Warehouse Development: 7 Princes Hwy, Dandenong South

Traffic and Transport Assessment

Subject Response To Functional Access Road Safety Audit (RSA)

IMPACT® engaged **Road Safety Audits®** to undertake an RSA (reference no. 15795) of the proposed functional layout plan of the access design to the proposed development at 1-27 Princes Highway. Specifically, drawing number IMP2203006-FLP-01-A.

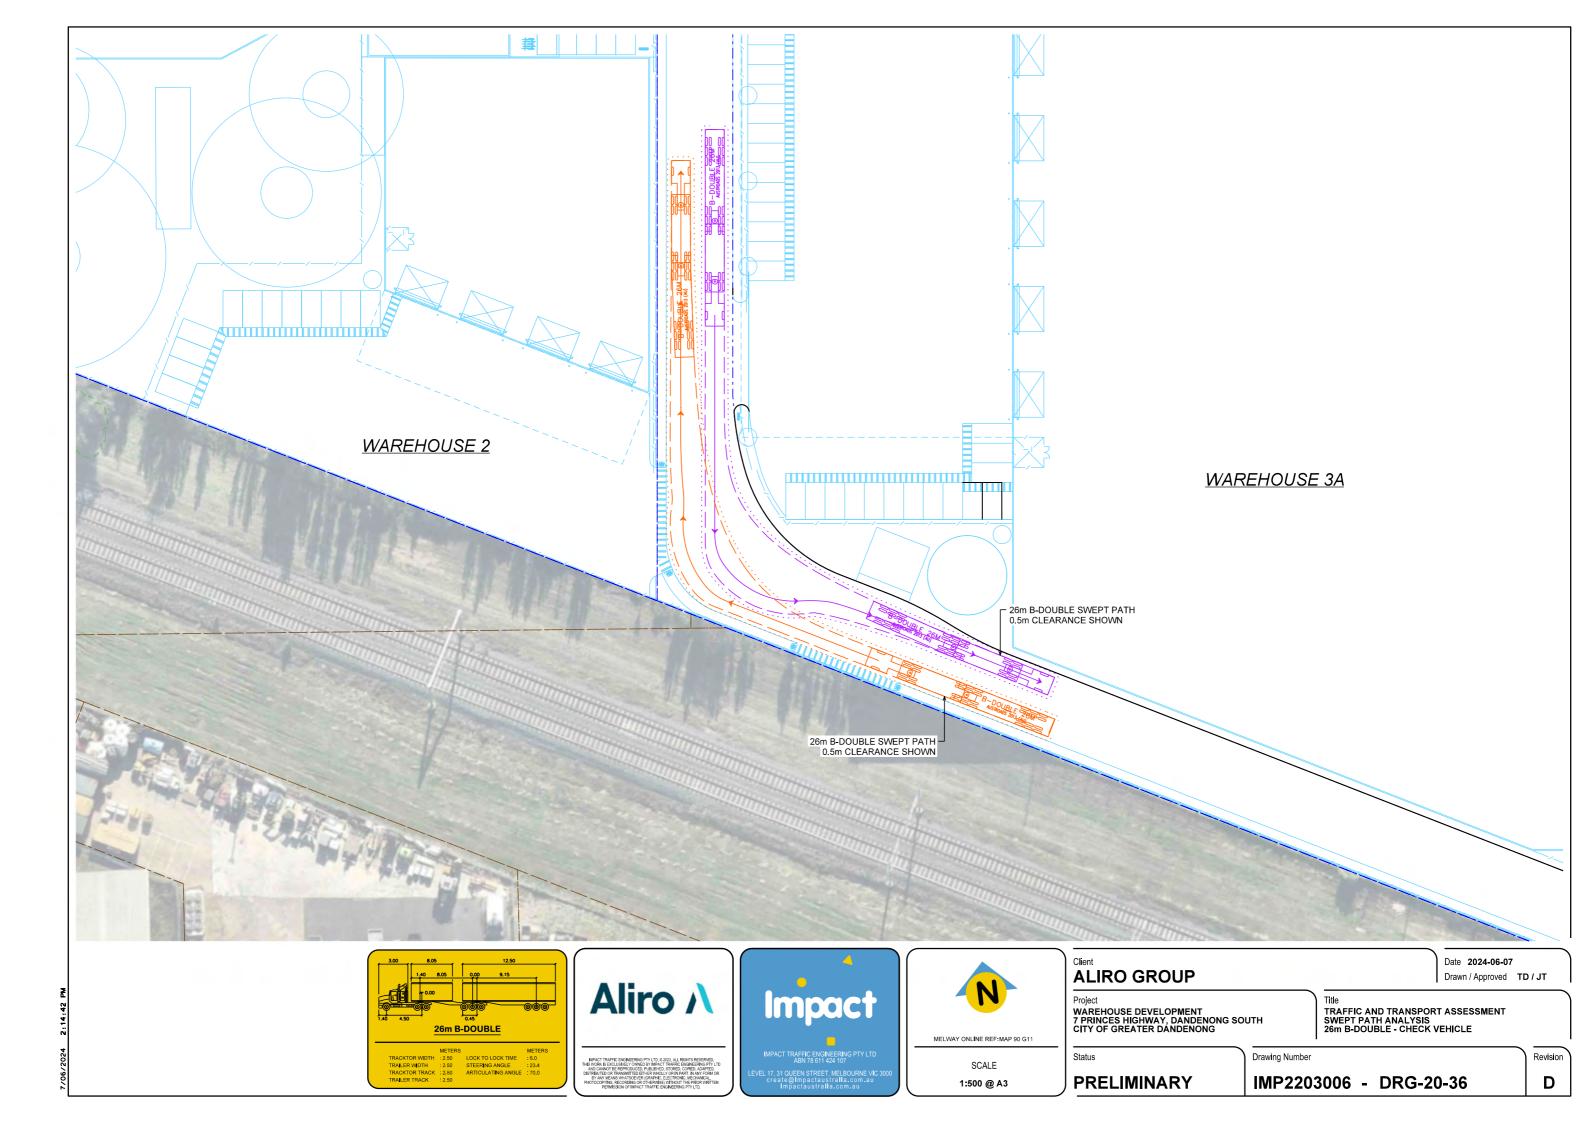
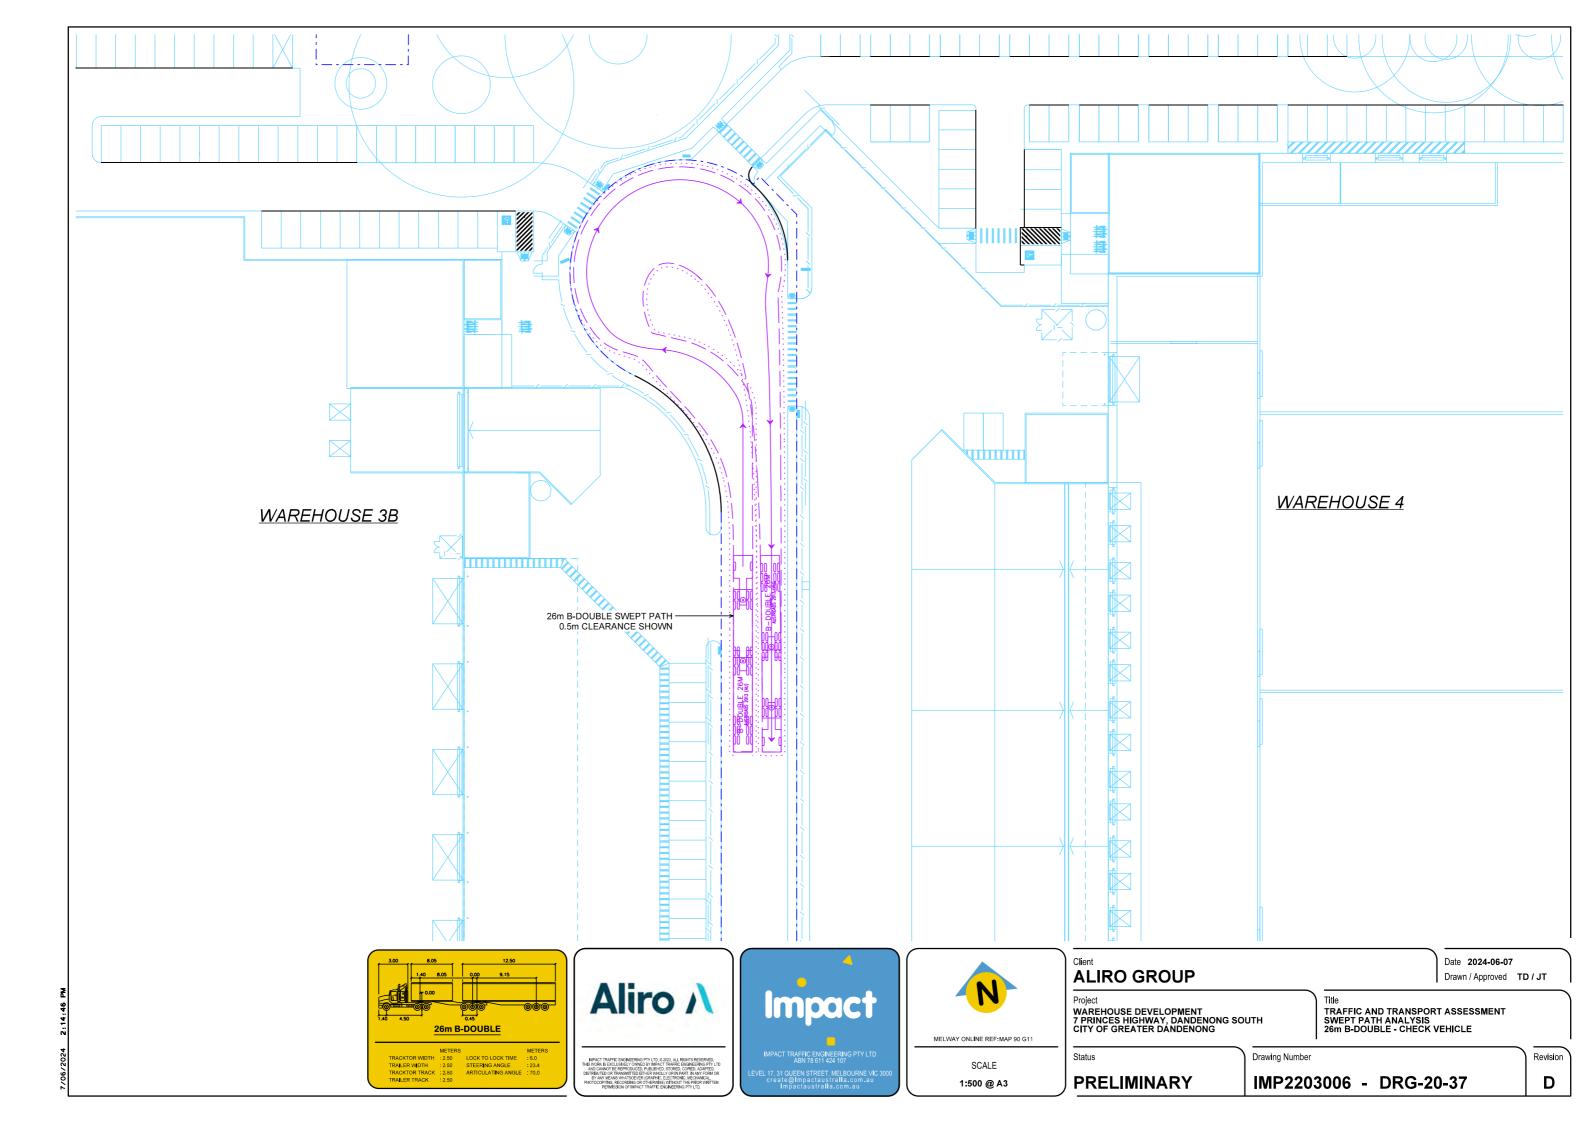
RSA Reference: 15795		15795	(1-27 Princes Highway, Dandenong South)		
			Responder: Jake Townley	Date: [14/05/2024]	
Point	RSA Risk Rating	FSI*	Response	Accept / Reject	
1.	L		Drawings updated to include give-way treatment and widen intersection to facilitate simultaneous truck movements	Accept	
2.	L		Trees to be maintained during operation.	Accept	
3.	M		Appropriate lighting to be installed. To be investigated by others in detailed design	Accept

In summary, the functional layout plan has been updated to reflect the recommendations given in item 1 and item 2. Lighting concerns, as mentioned in item 3, is accepted and deferred to be handled by others in the detailed design stage.

Updated drawings (Revision D) and a tabulated response to the RSA findings are attached as an annex to this note.
